**STAFF REPORT ON PRELIMINARY PLAT APPLICATION
FILE NO. Z20-039PPLT**

- 1. DESCRIPTION OF PROPOSAL: The applicant is proposing 45 new single family lots on approximately 12.15 acres located on parcel number 34071.0040, unassigned address, east of Tangle Heights Drive, utilizing Boulder Ridge Drive.

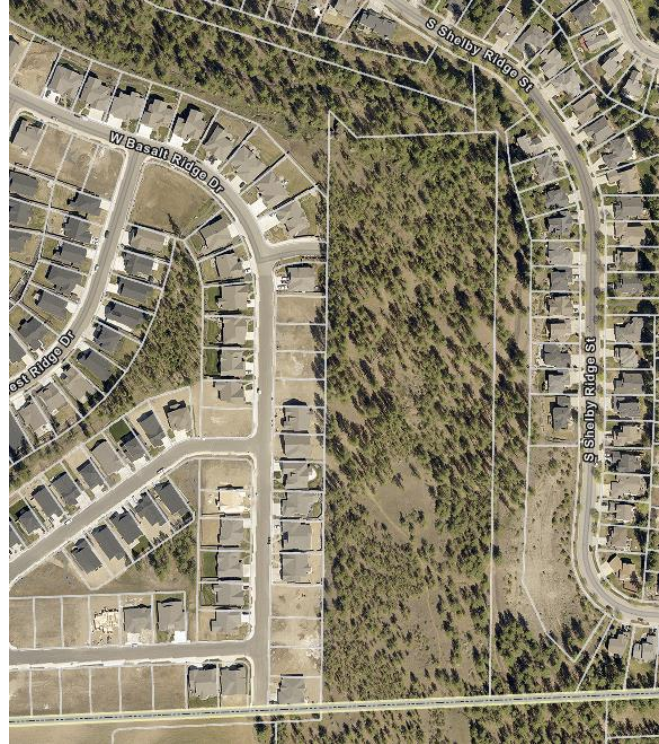
The proposal meets the minimum density requirements, minimum lot size and frontage requirements for the residential single-family zone, per 17C.110. The proposed plan will need to be revised to show lots 1, 2 & 3 meet the minimum depth of 80 feet. There appears to be adequate area to shift the road east to accommodate this depth on the west side of the proposed roadway.

1. Lots 1, 2 & 3 must meet the minimum lot depth of 80 feet.
2. Per the MDNS, vehicular traffic from this project is expected to deteriorate the level-of-service and negatively impact safety at the intersection of US 195/Meadowlane. Tangle Ridge may not final plat any lots until a financial commitment is in place (secured by a letter of credit or bond), which has been approved by the City, providing for the construction of the J-turn improvement at US195/Meadowlane. This commitment may be defined as an agreement between several developers to fund and construct the J-turn within a specified time frame, not to exceed six years, as agreed upon by city staff and WSDOT. The J-turn project will consist of removing the eastbound left from the US 195/Meadowlane intersection and provide a J-turn opportunity south of the intersection. The applicant's contributions to funding the design and construction of the Meadowlane/US 195 J-turn project will qualify for a credit against transportation impact fees per SMC 17D.075.070
